## **TR010056: A417 Missing Link Updates**

**Subject:** A417 - Missing Link ExQ1 1.11.21

**From:** [REDACTED]  
**Sent:** 22 January 2021 18:47  
**To:** 'Allan Pitt' <allan.pitt@arup.com>  
**Subject:** RE: A417 Missing Link - WCH Statement of Common Ground minutes

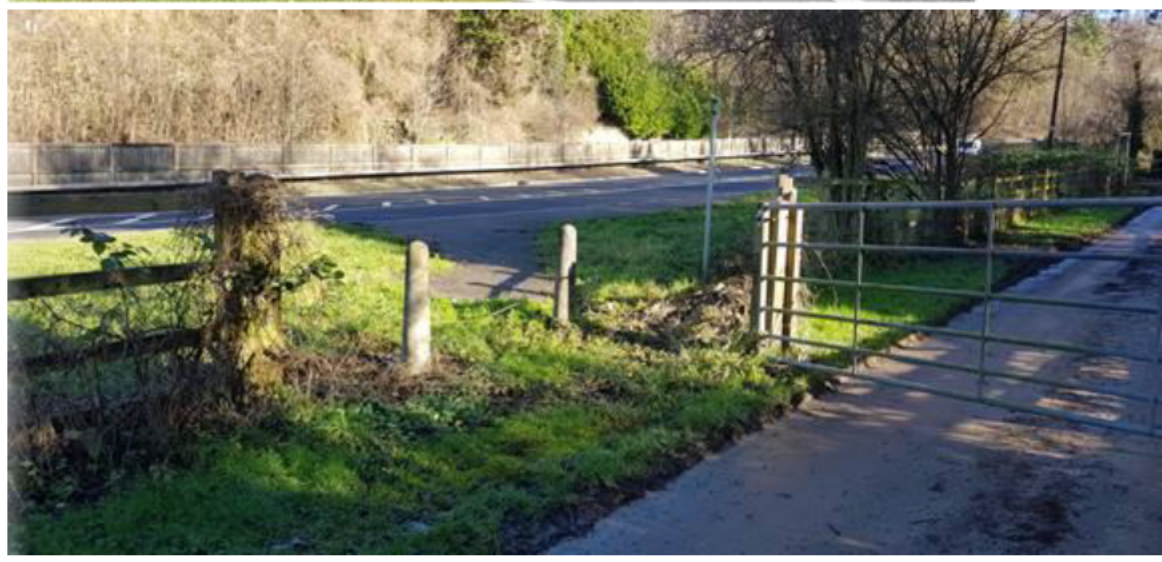
2.21: Fig 2 shows the existing formal provision of FPs 77/74/80/84 from the South of The 417 to the edge of the A417 to the South, but does not show the corresponding access to the North, where it states that there is no connection. The Google Earth images (below, marked up with the approximate FPs 80 position in brown) contradict this – a clear existing connection is shown slightly to the West. There is a fence and locked iron gate across the path, but there is a chicane access between the two to enable unrestricted passage. (Noted that this chicane is not obvious from the South, although the gate and access of course is).

Here is the North connection – you do not even have to climb a style, simply walk around the open chicane. Both photos clearly show significant signs of use by the wear on the ground around the end of the chicane.

Here are snaps of the (ample) central reservation at the crossing, and the Southern access of FP80. I had no difficulty finding a gap in the traffic where the lane I was crossing had no visible traffic, but the lockdown will have reduced traffic generally.
